VIRGINIA ELECTRIC AND POWER COMPANY
RICHMOND, VIRGINIA 23261

July 24, 1981

GENERATOR BREAKER ADDITION AND
GENERAL DESIGN CRITERIA 17 ANALYSIS
NORTH ANNA UNIT NOS. 1 AND 2

ELECTRIC POWER SYSTEM
GENERATOR BREAKER SECTION &
EVER TO NORM BUS TIES
NORTH ANNA UNIT 5, 1 & 2
BRIDGE & W. JORDAN INDUSTRIES CORPORATION
1205047 SR-1

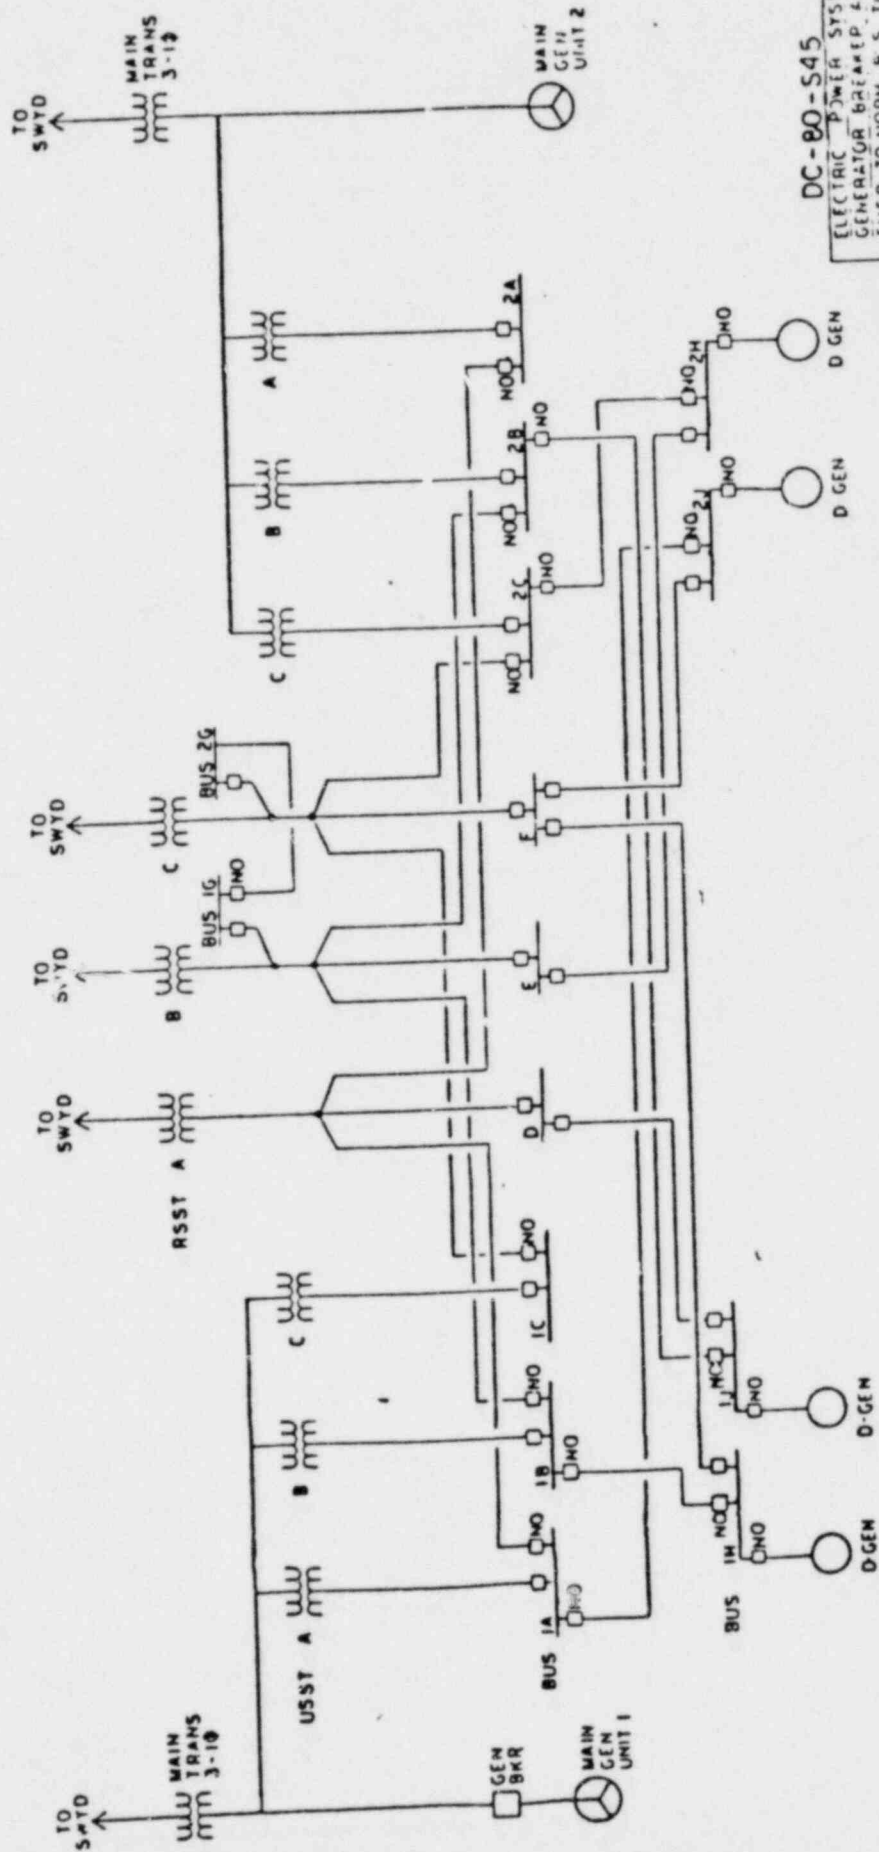
In our letter to you dated September 24, 1980, Serial No. 725A, we discussed the installation of generator breakers for North Anna Units 1 and 2. We have installed a generator breaker on Unit 1 and are presently analyzing the adequacy of this single installed breaker in providing a permanent solution to the General Design Criteria 17 (GDC-17) concern at North Anna. A one line diagram showing the present situation at North Anna is attached.

To establish two independent offsite power sources to each emergency bus, normal to emergency bus ties will be utilized on each unit. Presently, the Unit 1 ties have been installed and are in service. These ties consist of Bus 1B to Bus 1H and Bus 2B to Bus 1J ties. It is our intention to install the Unit 2 ties during the next scheduled Unit 2 refueling outage (Spring 1982). The Unit 2 ties will consist of Bus 2C to Bus 2H and Bus 1A to Bus 2J ties. All of the normal to emergency bus ties have a normally open breaker at each bus. In conjunction with this modification, the administrative ties between buses 1H and 1J have been removed. The administrative ties between buses 2H and 2J will be removed during installation of the Unit 2 normal to emergency bus ties. The bus ties will operate as follows:
